TECHNICAL BULLETIN

[Issue No.] T10-0031

[Title] Improved display quality (intensity, view angle and contrast ratio) of GOT-A900 series for visual comfort

[Relevant Models] A975GOT-TBA-B, A975GOT-TBD-B, A970GOT-TBA-B, A970GOT-TBD-B

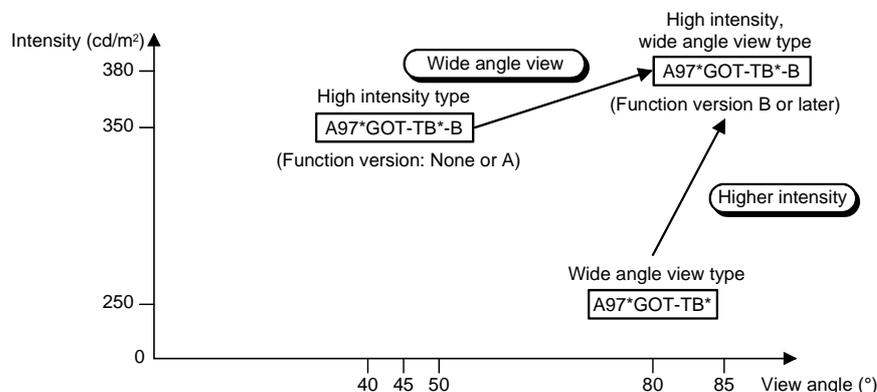
By upgrading to function version B, the above GOT models display quality (intensity, view angle and contrast ratio) have been improved, as well as display life and backlight life. Further details are given below.

Example) A970GOT-TBA-B of function version B

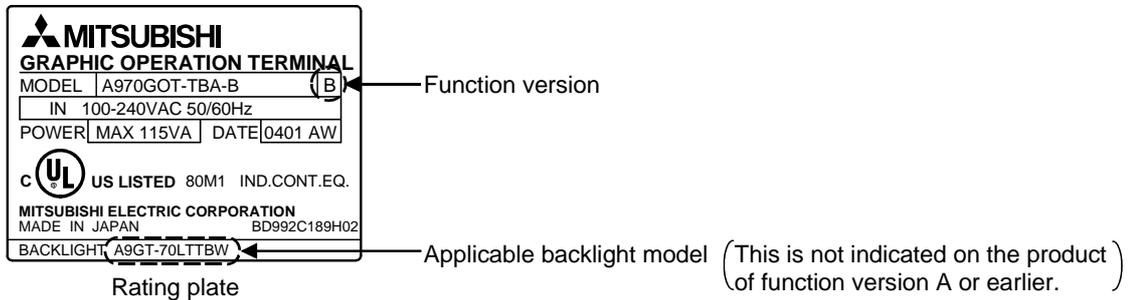
The GOT function version and the applicable backlight model are shown on the rating plate at the rear of the GOT.
